Service Bulletin

Model : GP605

No.: GP605-004 Rev. 2
(FF-T01-K1-000011-03)

Subject : PREVENTING ADF REVERSING FLAPPER FROM STAYING OPEN

Fig. 1

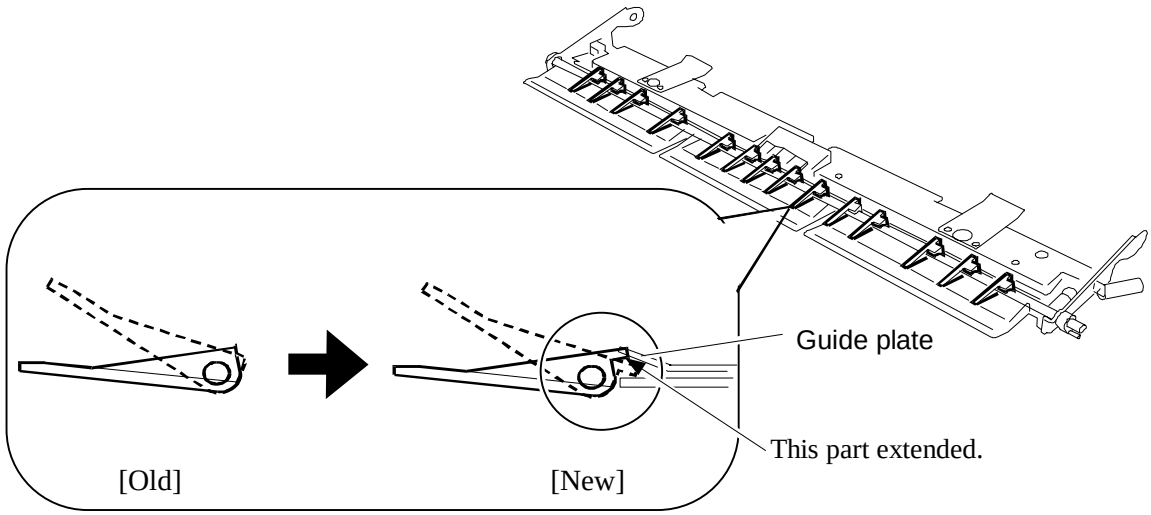
Details : <Symptom>
The user in the course of clearing a jam in the ADF tries to manually open the flapper at the lower part of the ADF, and finds oneself that the flapper stays open.

<Cause>
In the course of clearing a jam at the lower part of the ADF, the lower guide cover indicates that it should be opened with the hands, but depending on how the user opens it, the flapper stays open.

<Factory measure>
The reversing flapper has been extended with a change in the shape to prevent overriding the guide plate. (Fig. 1)

Fig. 11

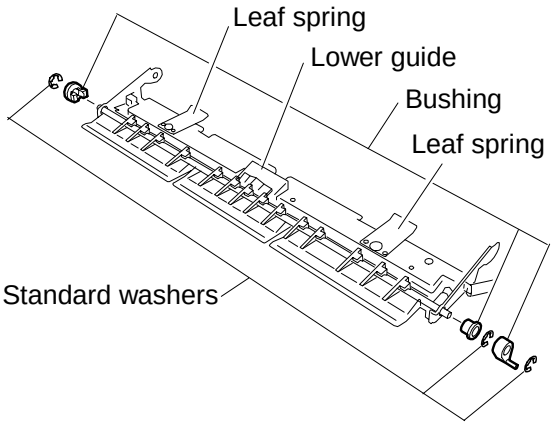
10) Remove the 3 standard washers from their locations and remove the shaft.
11) Replace the reversing flapper with its countermeasure replacement, and re-attach the bushing and the standard washers. (Fig. 11)

If it is noted that the flapper stays open, replace also the lower guide at the same time.

* When replacing the lower guide, be sure to use the leaf spring while repalcing the guide with a new one.
